**NCC 2022 Section J Vol. 1 J1V3 Assessment**  
**135 Badgerys Creek Road, Bradfield**  
**Creative Vision**

Issue	Project	Description	Author	Checked	Date
1.0	P22001	NCC Section J 2022 J1V3 Assessment	SN	LW	29 <sup>th</sup> August 2025

Aspire Sustainability Consulting has been engaged to assess the non-Class 2 components of the proposed mixed-use development at 135 Badgerys Creek Road, Bradfield, NSW 2556, against Section J Verification Method J1V3 of the 2022 National Construction Code (NCC) Volume 1. This advice covers Section J Parts J4-J5. J Parts J6-J9 must be achieved in design by relevant services disciplines for the whole development.

APPROVED AS	CHECKED DC	DRAWN	DRAWING NUMBER DA-1004	REVISION A

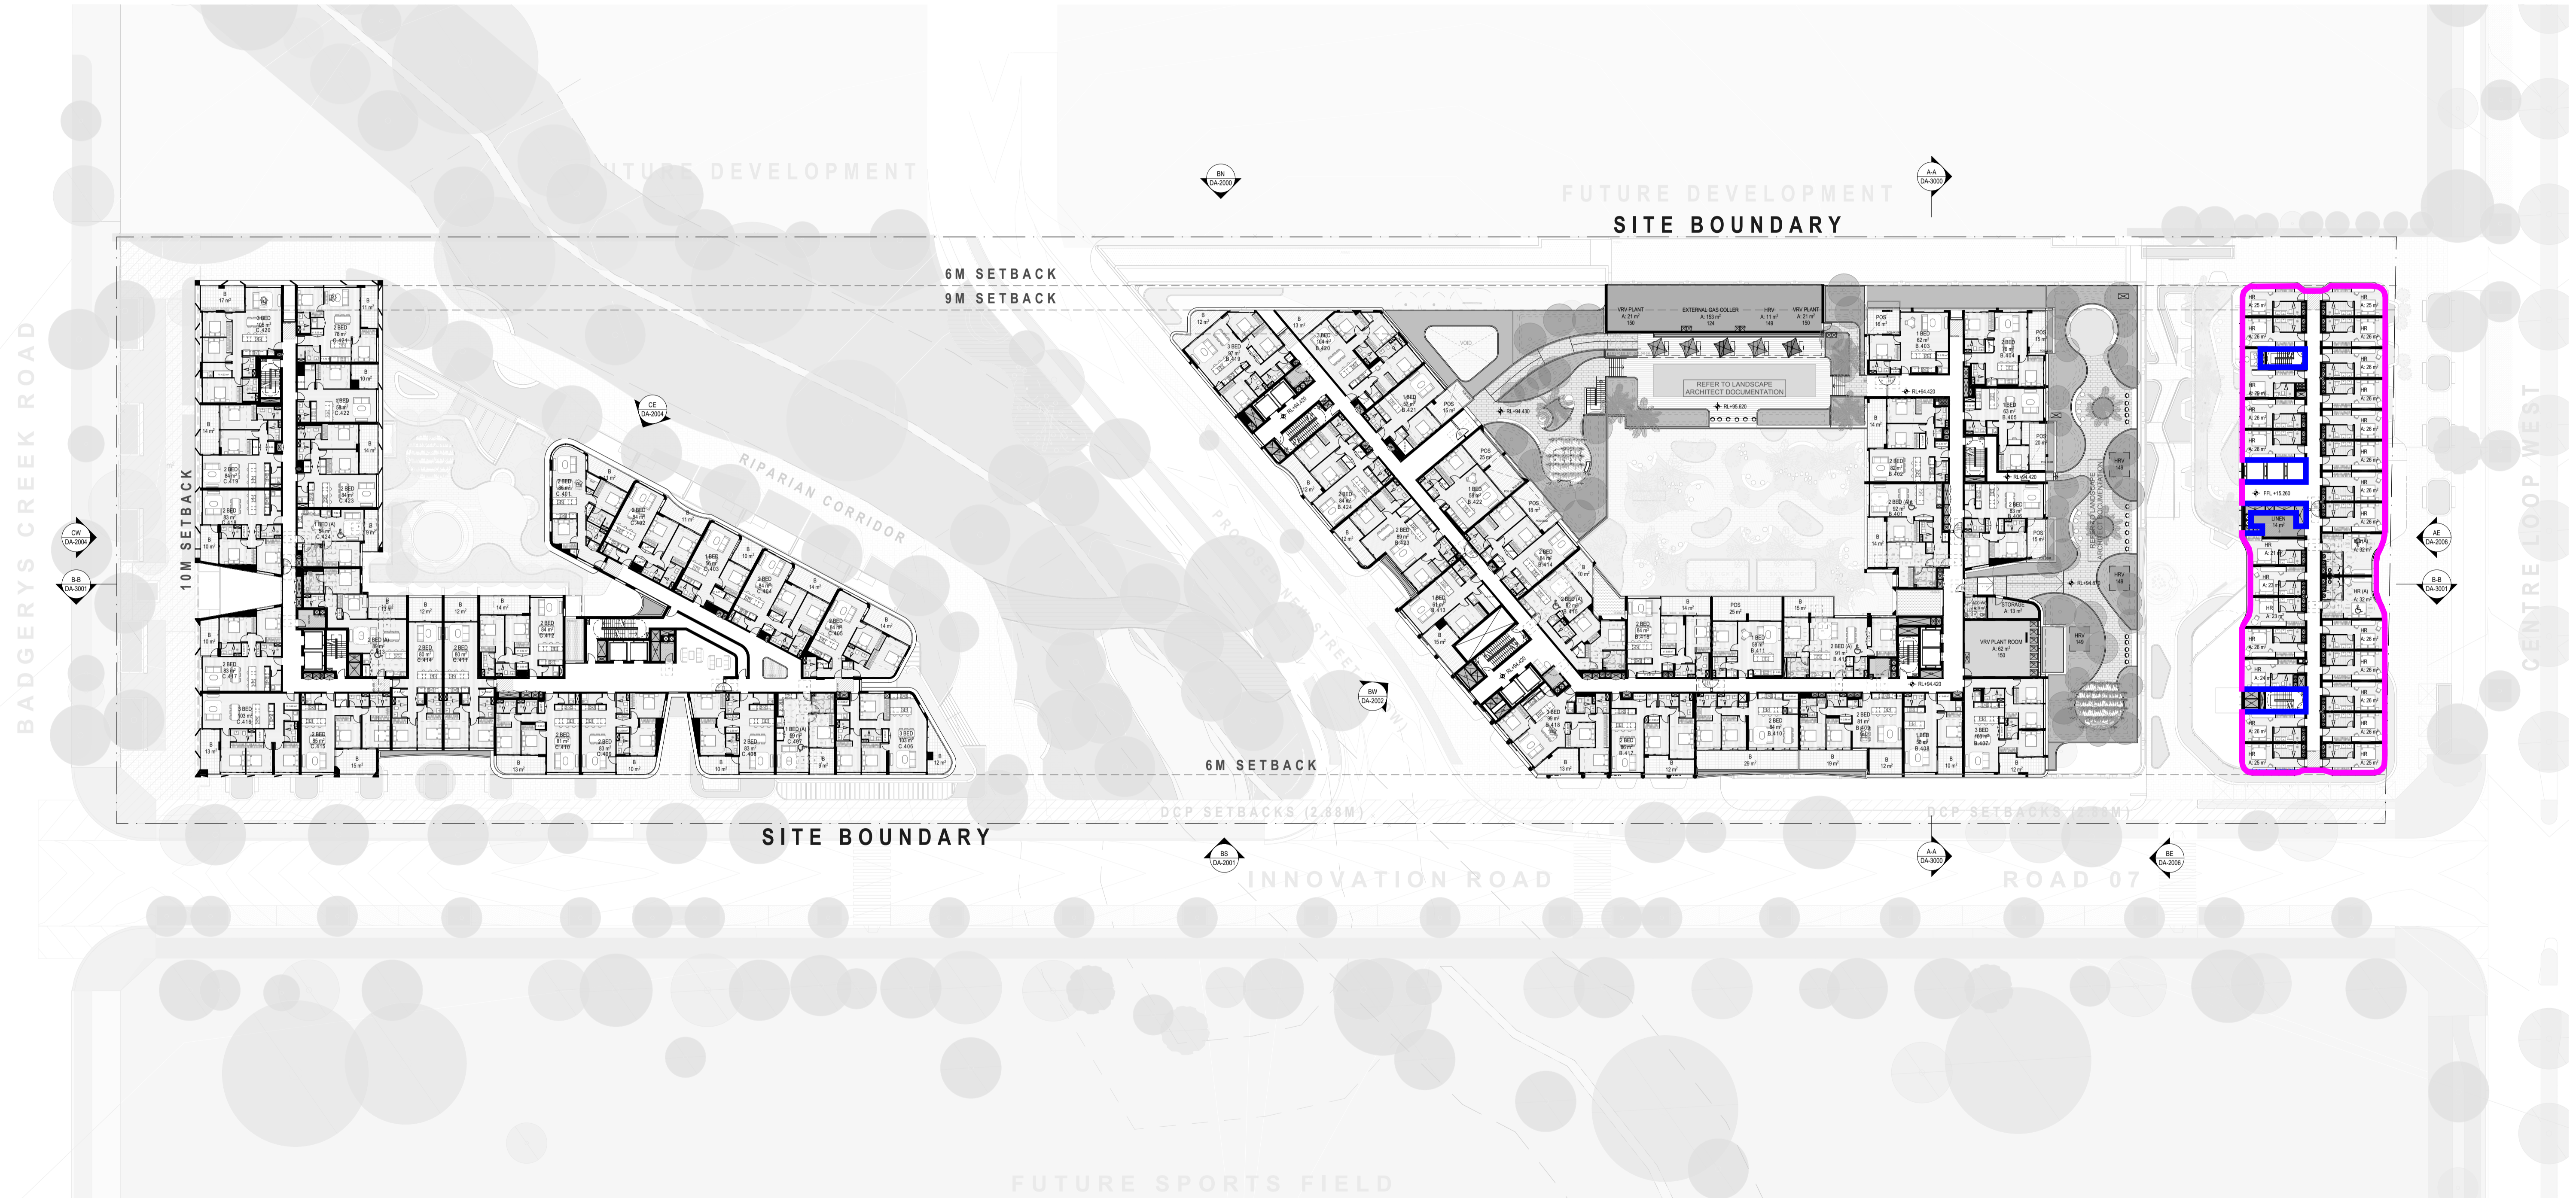
Roof:

Ceiling:

Floor:

External Wall:

Internal Wall:

Please refer to Section 5.1.1, 5.1.3 & 5.1.5 for detailed requirements regarding the required R-values for building fabric within the Thermal Envelope.

PROJECT NUMBER  
20799  
DRAWING NUMBER  
DA-1005

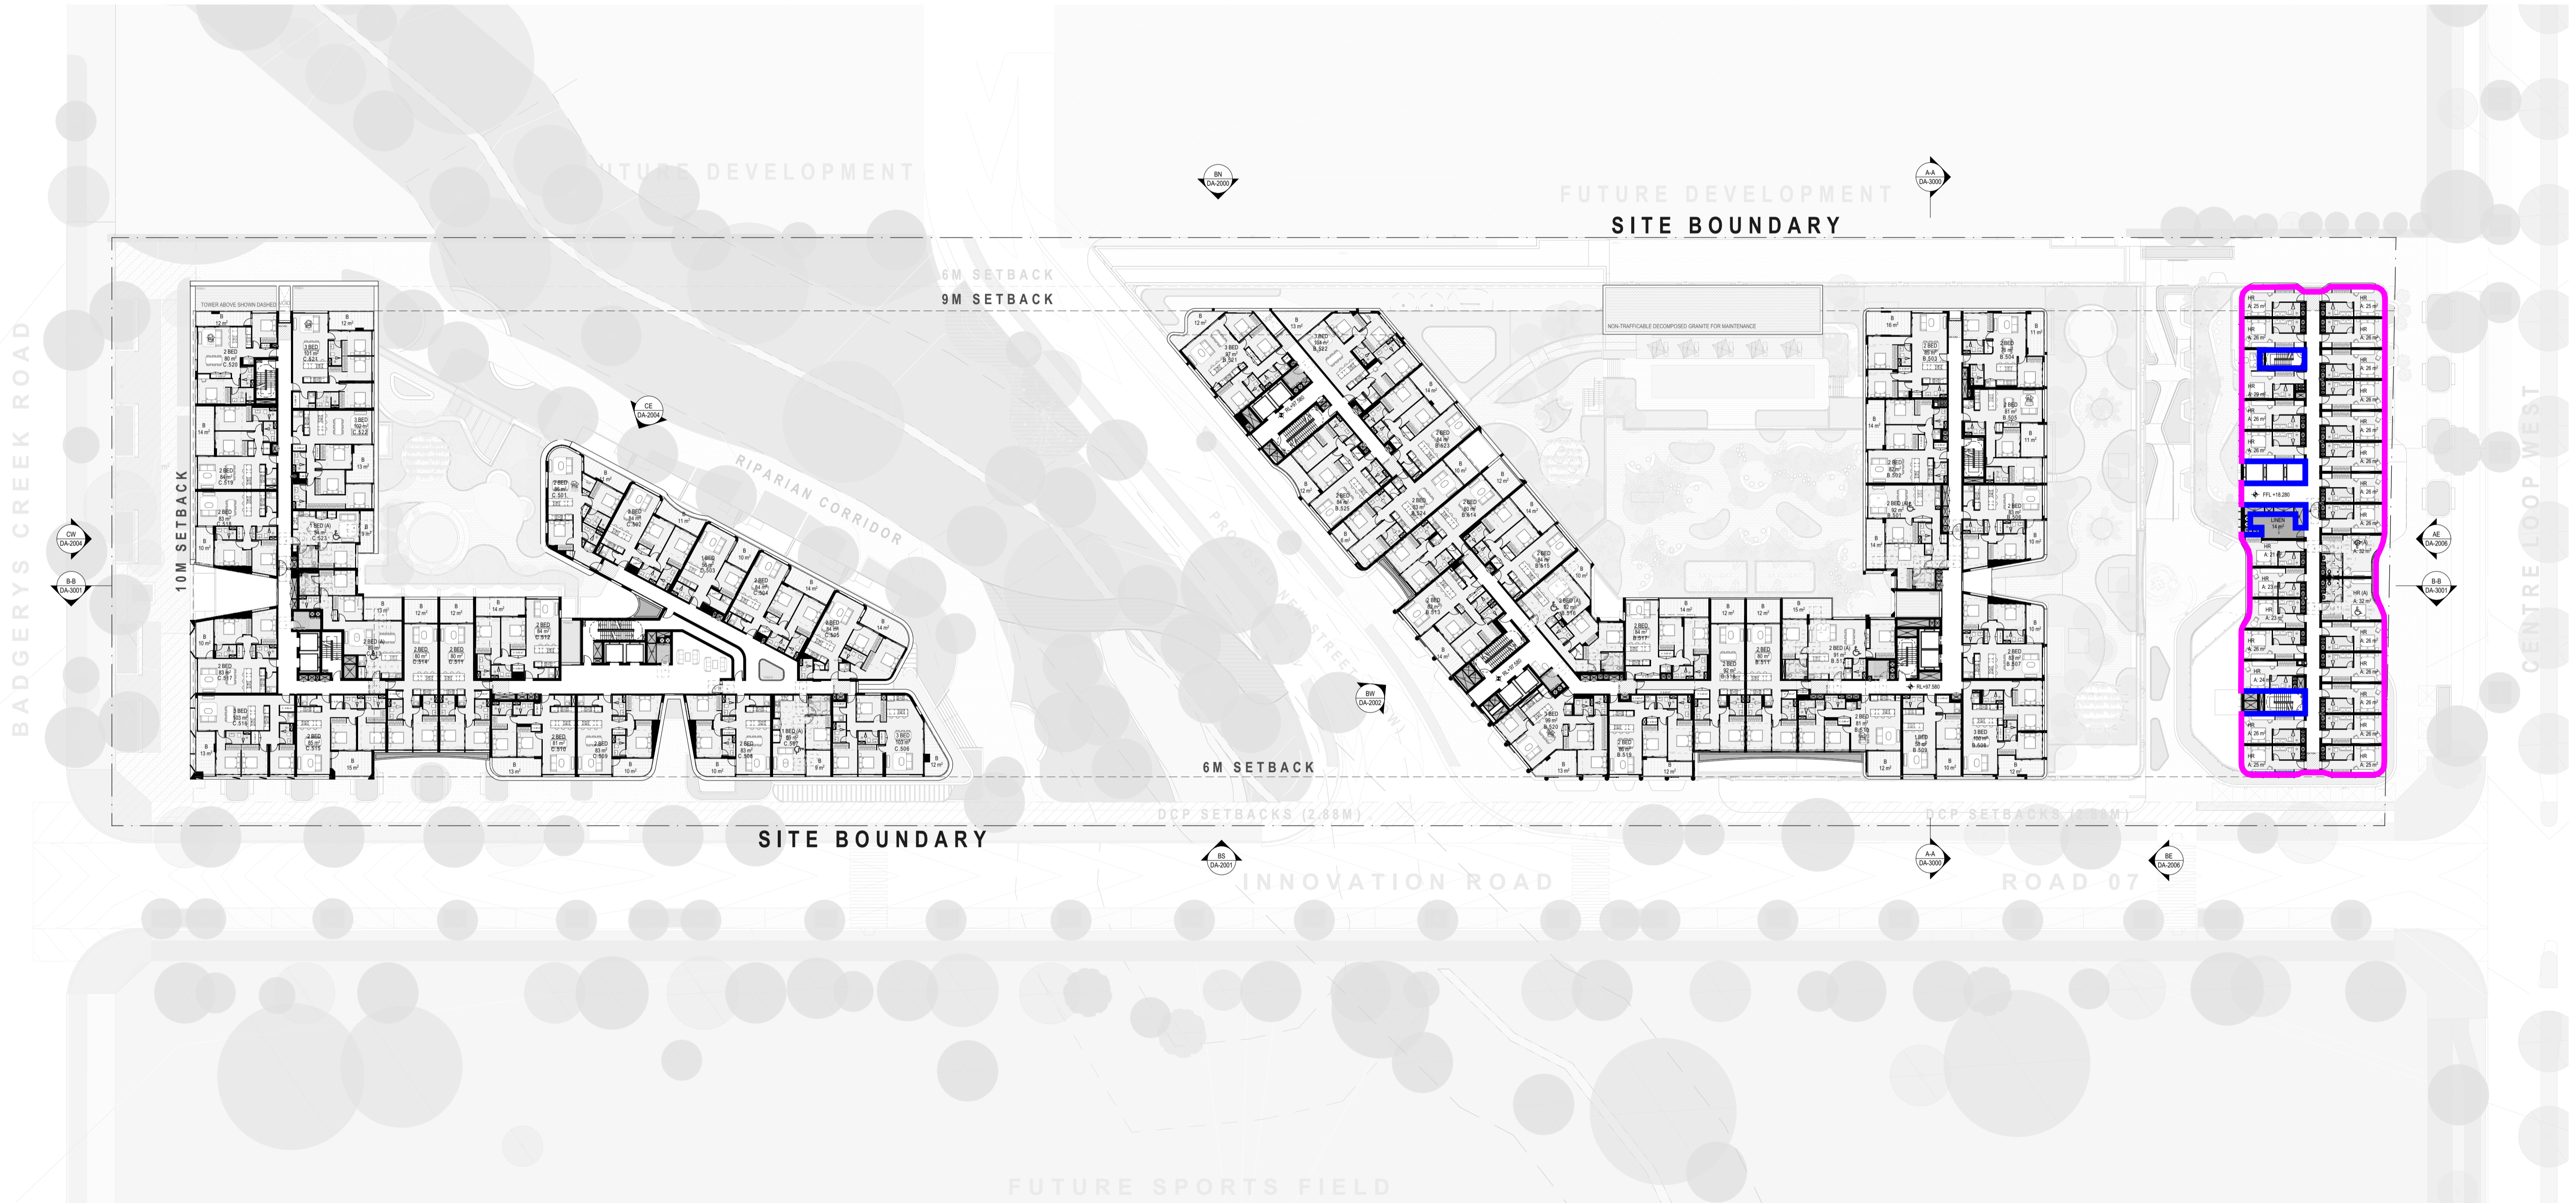
Roof:

Ceiling:

Floor:

External Wall:

Internal Wall:

Please refer to Section 5.1.1, 5.1.3 & 5.1.5 for detailed requirements regarding the required R-values for building fabric within the Thermal Envelope.

DRAWING NUMBER  
DA-1011

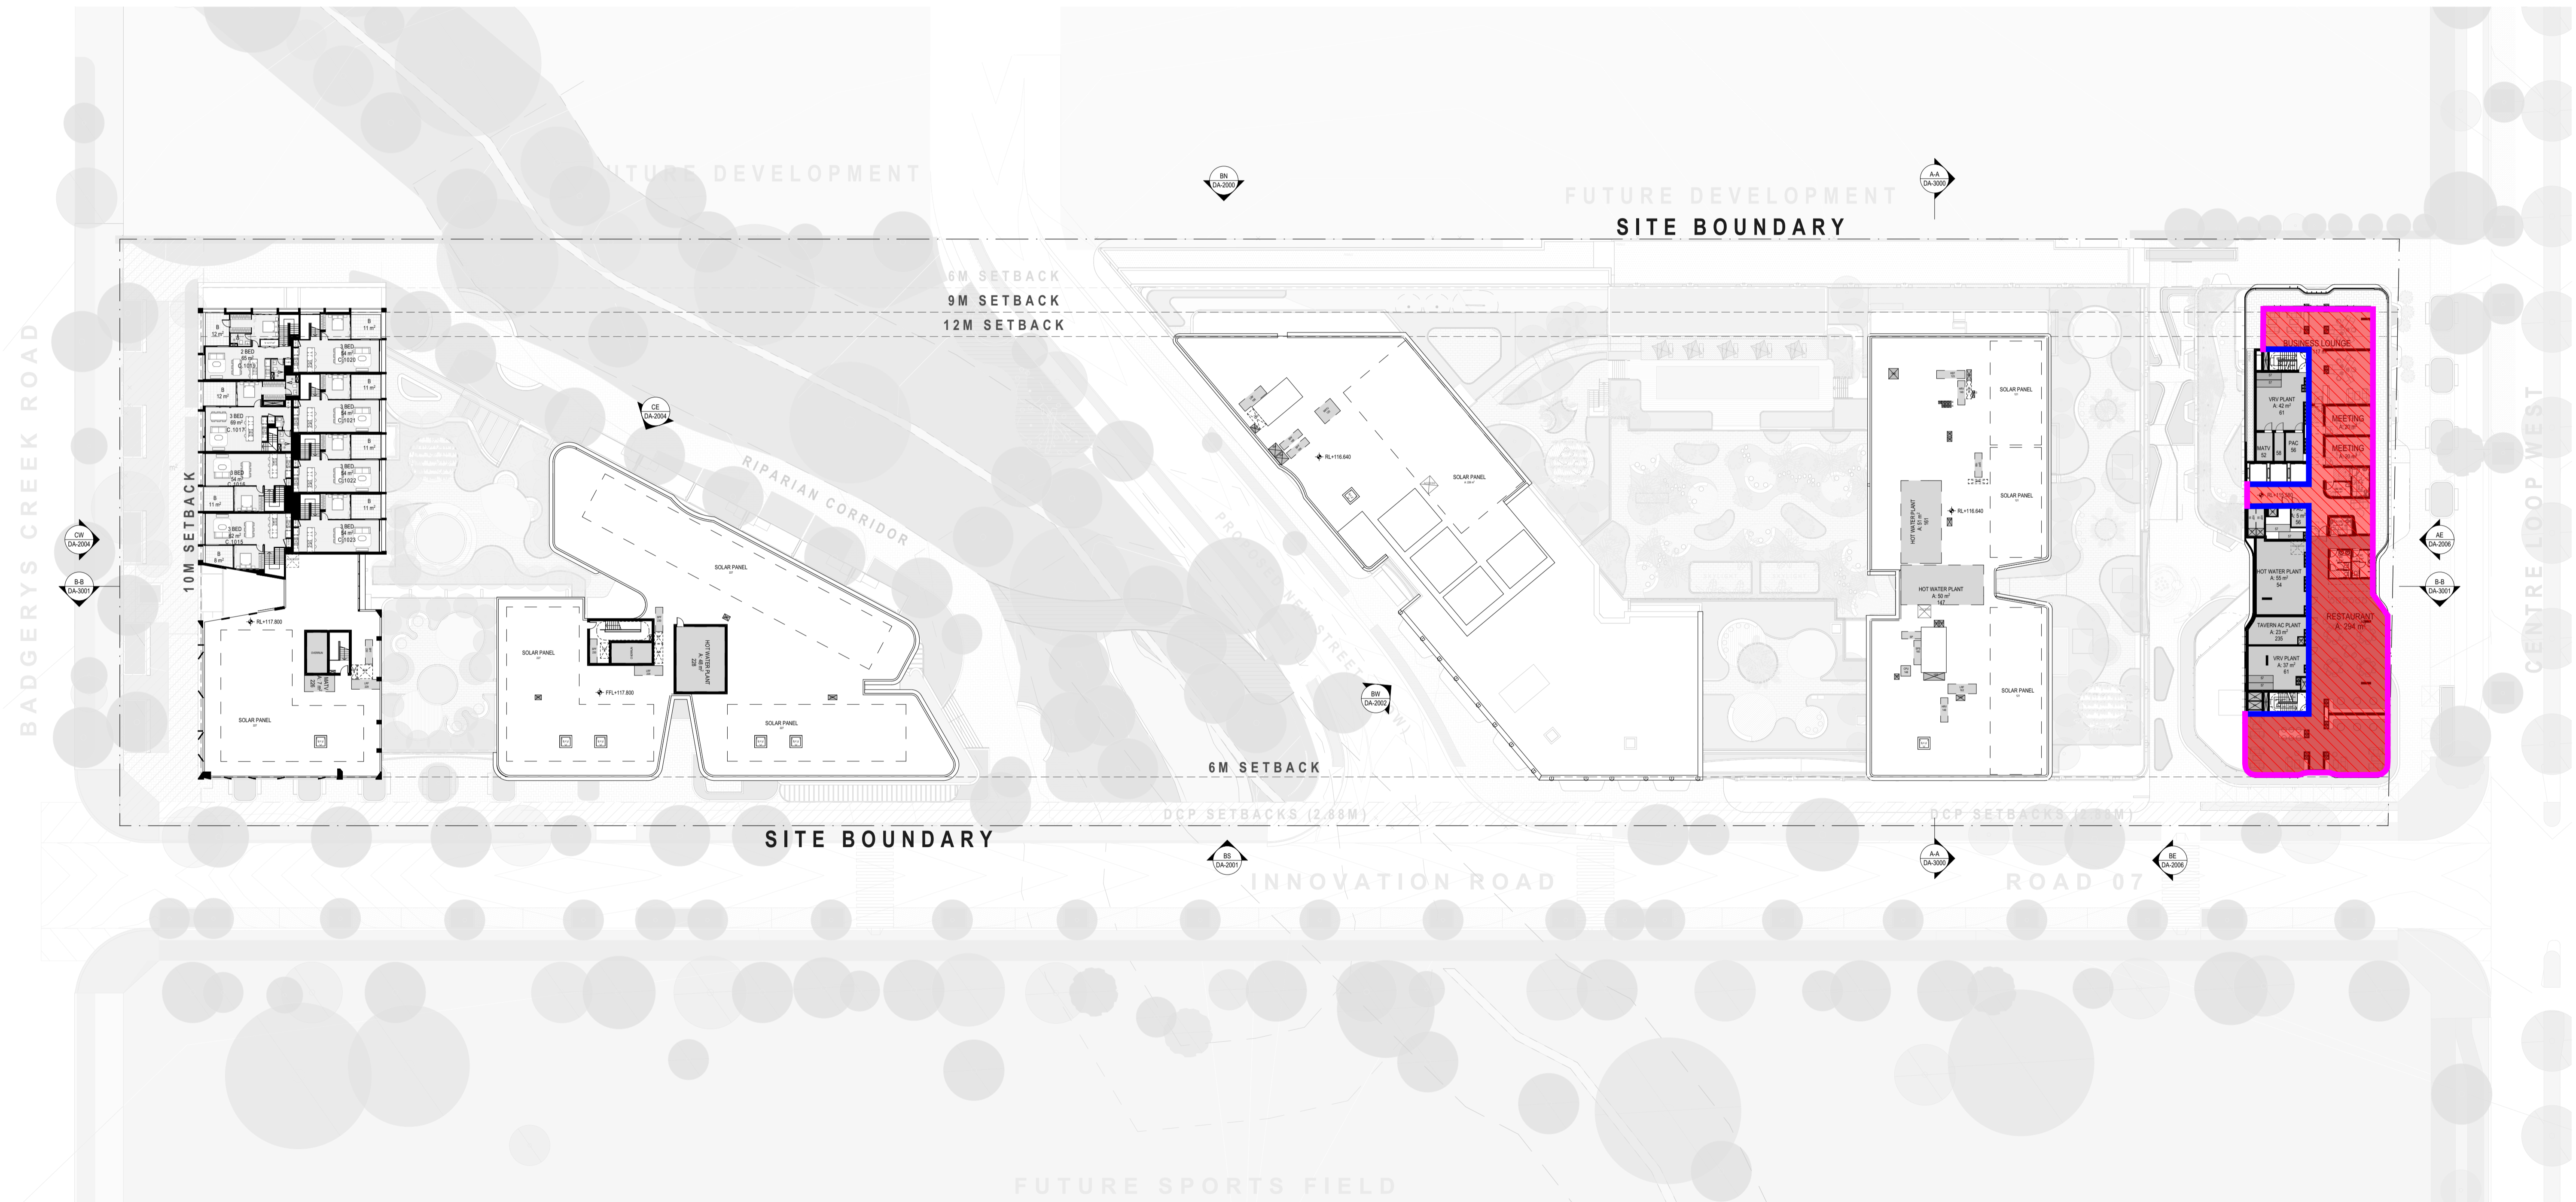
Roof:

Ceiling:

Floor:

External Wall:

Internal Wall:

Please refer to Section 5.1.1, 5.1.3 & 5.1.5 for detailed requirements regarding the required R-values for building fabric within the Thermal Envelope.
